**Our Case Number:** ABP-316272-23

**Re:** Bus Connects Templeogue/Rathfarnham to City Centre Core Bus Corridor Scheme  
Templeogue/Rathfarnham to City Centre

## Response to NTA Observations on the Proposed Scheme Submissions

### Construction Compound TR3 Location

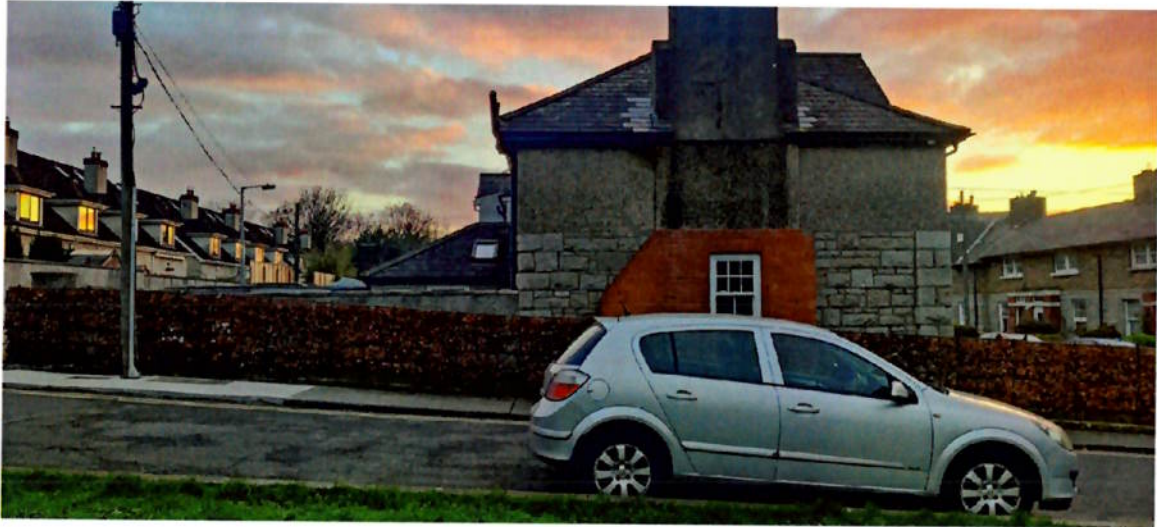
The proposed construction hours are wholly inappropriate for a construction site in a residential area. The hours of construction impact all aspects of the operation of the site and exacerbate many of the issues being raised in opposition to the location of the site including pollution from noise, light and fumes; parking; health and safety. The proposed construction hours are required for the NTA to achieve their completion target of two years and serve no other purpose. No residential construction project would be granted permission to operate on the proposed construction schedule of Bus Connects and nor should they. Neither is the disruption at the site truly temporary, as might be accommodated outside someone's home on the route during construction. This is the locus for all construction on the route and will be operational at all times throughout the construction period.

Image 5.3: Location and Extent of Construction Compound TR3

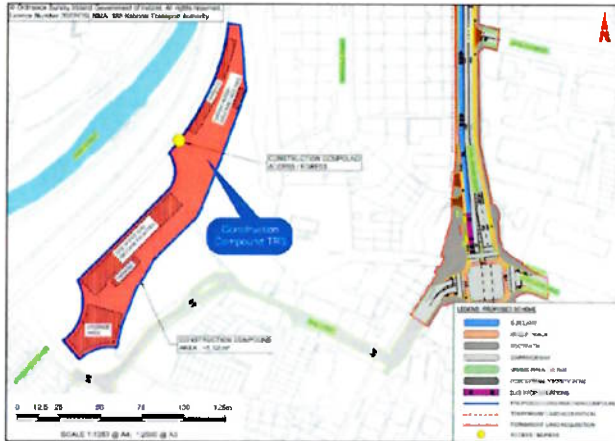
Construction Compound TR3 will be located along Dodder View Road, across the road from Bushy Park, in the greenfield area between Dodder View Road, Woodview Cottages and Church Lane, as shown in Image 5.3. The area of Construction Compound TR3 is approximately 5,120m<sup>2</sup>.

The images below are of the egress as identified in the construction site map (right). They show the narrowness of road, the new wide footpath (which will be unusable at the site entrance, requiring an additional pedestrian crossing on the Rathfarnham bridge side of the site entrance) and the closeness of the cyclelane on the opposite side of the road, which will be required to create space for vehicles to exit and safely enter the site.
